Access Compliance Report

Public Rights-of-Way

(Curb Ramps)

Intersection ID: 47122	Main Street: THOMPSON_BROOK_LN	Cross Street: DION_AV	Location: SW
ADA ID: F626F81A8D8D	Ramp Type: BlendTrans1	Initial Pass/Fail: Fail	Overall Compliance: No
Severity Score: 12.5			
Codes/Mitigation Info/Possible Solution		Field Measurements/Component Compliance

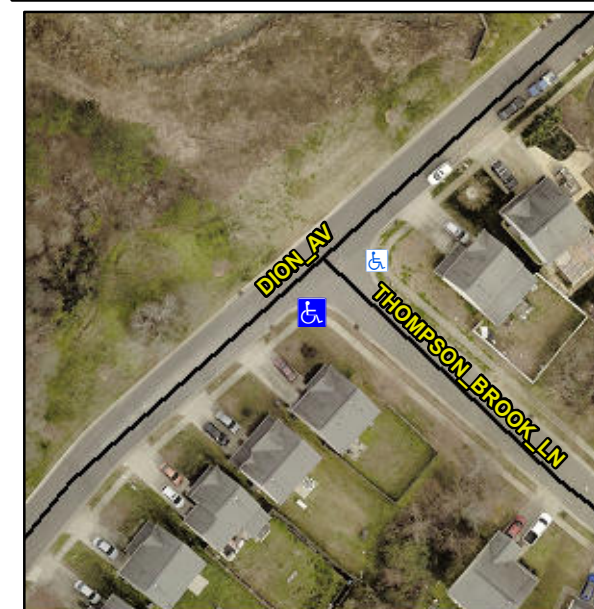
Not Found, R304.5.3

Remove & Replace Curb Ramp With Two New Directional Ramps or Equivalent.
